ADDENDUM NO. 1 December 3, 2024

Project: Skagit County Prosecutor T.I.

Electrical Room 346:

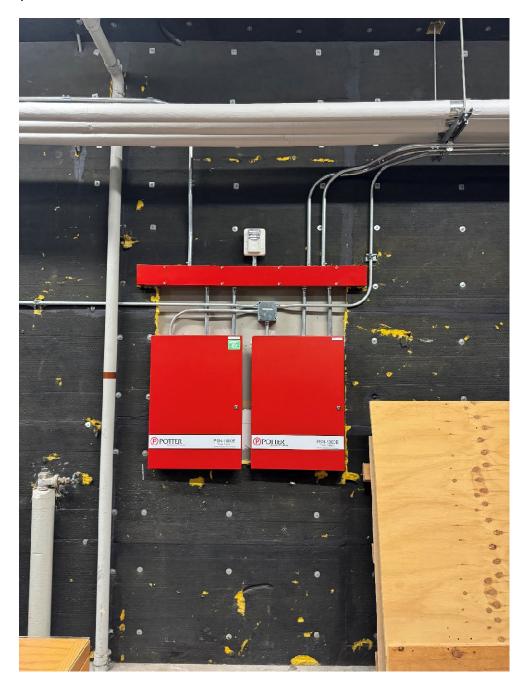
1. Existing room hosts a 20RU rack with six (6) Lucent 24-port patch panels for data, one (1) Lucent 16-port patch panel for voice and one (1) 12-port modular patch panel for data or voice. Assume each port is populated with cabling and jacks for a total of 172 existing cables.
